Westinghouse
Electric Corporation

RE-EKR-89-061

Subject: Application for Amendment for Certificate of Compliance
No. 5450 (Docket 71-5450)

The Westinghouse Electric Corporation hereby submits this revised application for an amendment to Certificate of Compliance No. 5450 (Docket No. 71-5450) for the RCC fuel shipping container. This revised application supersedes the previous submittal and addresses the NRC questions and issues presented to Westinghouse representatives during a meeting held on November 16, 1989. The only changes requested as part of this application are to increase the authorized maximum U-235 enrichment for Westinghouse 17x17 12-foot OFA fuel designs from 4.3 wt % to 4.85 wt % for two separate conditions. Either each assembly contains a minimum of 48 Integrated Fuel Burnable Absorber (IFBA) rods per specification and loading pattern described in Westinghouse drawing SKA-89044, or there is only one assembly shipped per container. These fuel shipments will be limited to the RCC type containers with Gadolinium Oxide poison plates.

SIZE	REON NO	DWG NO	REV	SHEET 01 OF 01	SHEETS
A	5555	SKA-89044	02		
SCALE	1/2		DWG TYPE

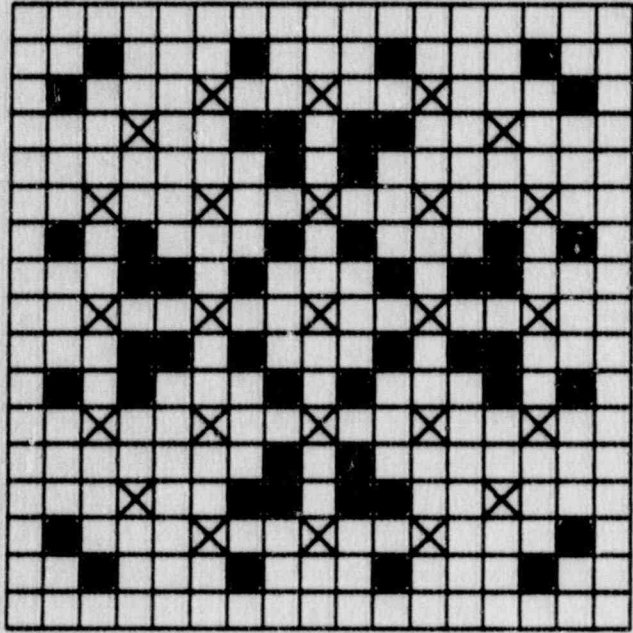
Attachment 19 has been revised to justify this U-235 enrichment increase from 4.30 wt % to 4.85 wt % with one assembly per container or with a minimum of 48 IFBA rods per assembly located in accordance with Westinghouse drawing SKA-89044. The calculated K-effective with the inclusion of a 95/95 confidence level (bias and uncertainties in the calculation and benchmark) are below 0.950.

1. Load pattern per Westinghouse Drawing SKA-89044.
